Grace's Place DA – Issues

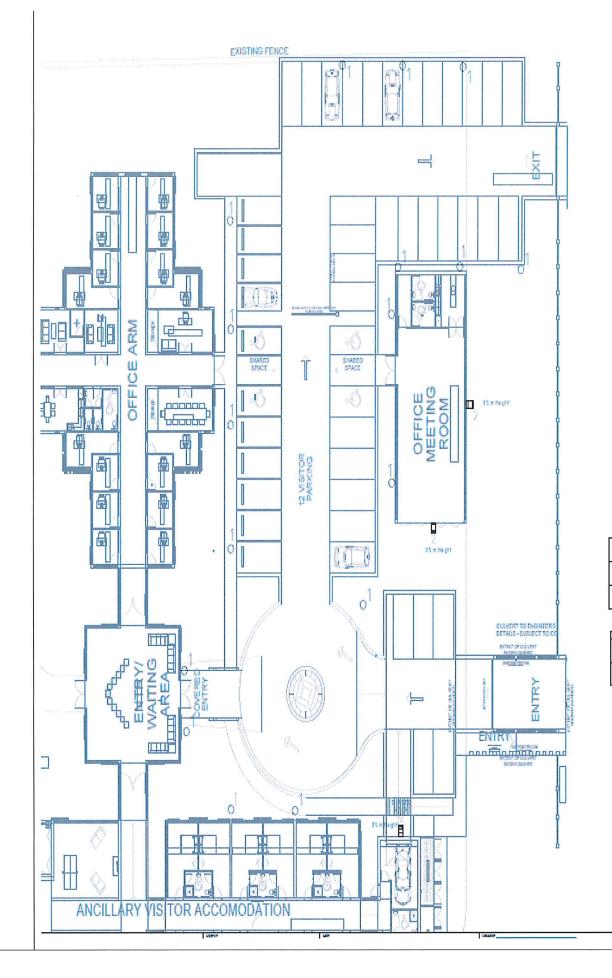
Lighting	Applicant's response
3. Lighting plan proposal to be submitted with lux report	An outdoor lighting plan has been submitted along with a lux report
	Lighting Plan:
	The lighting plan shows the location of lights surrounding the main of bollards and flood lights.
	3 flood lights near the main entry will be fixed at the height of 3.5 m proposed are bollard lights at 380 mm in height when attached to a the ground.
	These lights are located along the ancillary accommodation and ca lighting plan.
	Lux report:
	The report confirms that the proposed lighting will be installed in ac consistent with the requirements of Sections E, F and J of the Build Australian Standard 1158.3.1. Accordingly, the outdoor lighting plan surrounding neighbouring properties.
Original Plan	Amended Plan
Details were to be provided as part of the consent.

in entry and car parking area. The lights consist

o m above the ground level. All other lights o a wall/fence, or 600 mm high when attached to

car parking areas as detailed in the outdoor

accordance with standard engineering practice, uilding Code of Australia and the relevant blan will not result in offensive glare to the

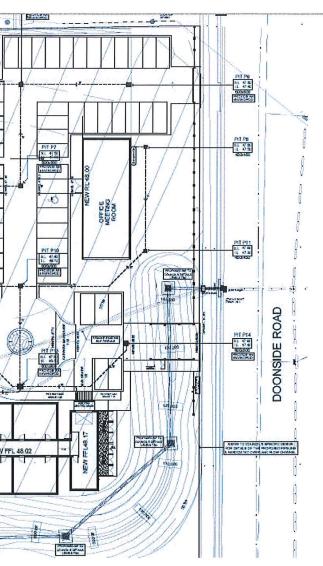
On-site detention	Applicant's response
4. On-site detention to be placed on site in accordance with the requirements of Council's engineers	Location of the OSD system is shown on the civil plans to the The OSD system will be located in the north-western corner o
Original Plan	Amended Plan
Details were to be provided as part of the consent.

ne satisfaction of Council's Drainage Engineer. [•] of the site.

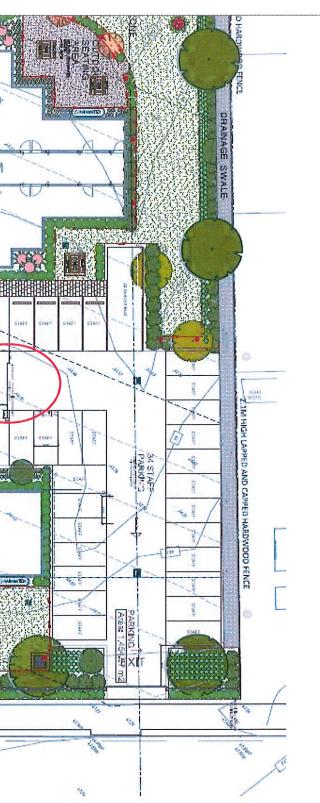
Overnight parking area	Applicant's response
5. A barrier to be placed so as to contain overnight parking area	A boom gate is now proposed to prevent cars to park along the residential properties.
	The boom gate will be located in the car parking area, betweer buildings approximately 25 m away from the residential bound
Original Plan	Amended Plan
Original Plan Details were to be provided as part of the consent.	Amended Plan

he north-western boundary adjoining the existing

en the office meeting room and the office arm dary to ensure the noise from cars is reduced.

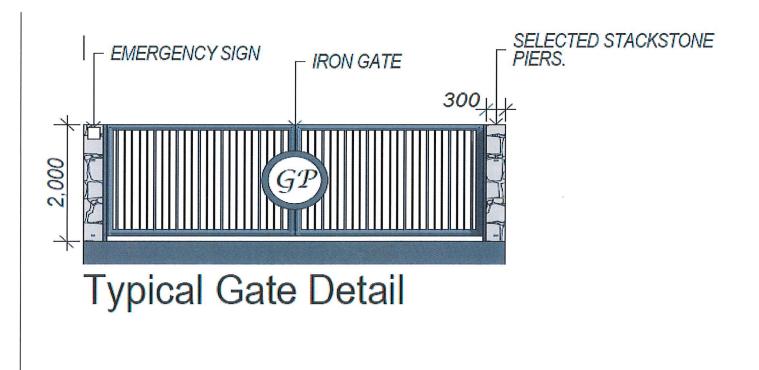
Emergency contact	Applicant's response
6. A sign should be designed for the front of the site showing an emergency telephone number Original Plan	A sign is now proposed to be located on the front entry gate. A metal sign of 190 mm x 185 mm dimensions is to be fixed Doonside Road. The sign will be white with black lettering and include the key well as other phone numbers in the case of an emergency. Amended Plan
Details were to be provided as part of the consent.	GRACE'S PL
	HVSG - 1800 19 hvsgnsw.org. Blacktown Local Police 000 Emergency Cont
	Peter Simpson - 040 Grace's Place Caretaker & Founding Member of the Martha Jabour - 041 Executive Director of the Homicide Victims'

onto the sandstone pier of the front gate facing

contact persons and their mobile numbers as

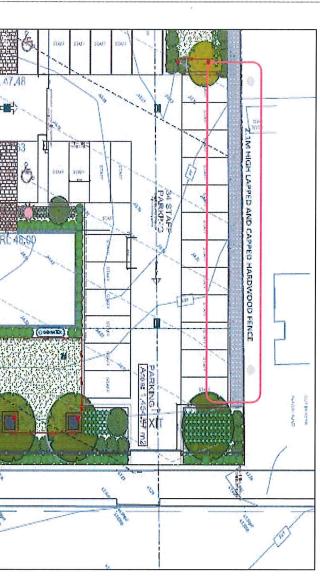
Landscaping plan	Applicant's response
Landscaping plan to be redesigned to accommodate the Council drainage swale at the north-wes boundary and to show all gates	(i) The revised landscape plan now submitted denotes proposed drainage swale along the north-western bo (ii) All proposed gates are shown on the submitted plan stormwater management on the site.
Original Plan	Amended Plan
Details were to be provided as part of the consent.	NEW READ DOORNSIDE ROAD

es that no trees will be proposed along the boundary.

lans and will not obstruct the relevant
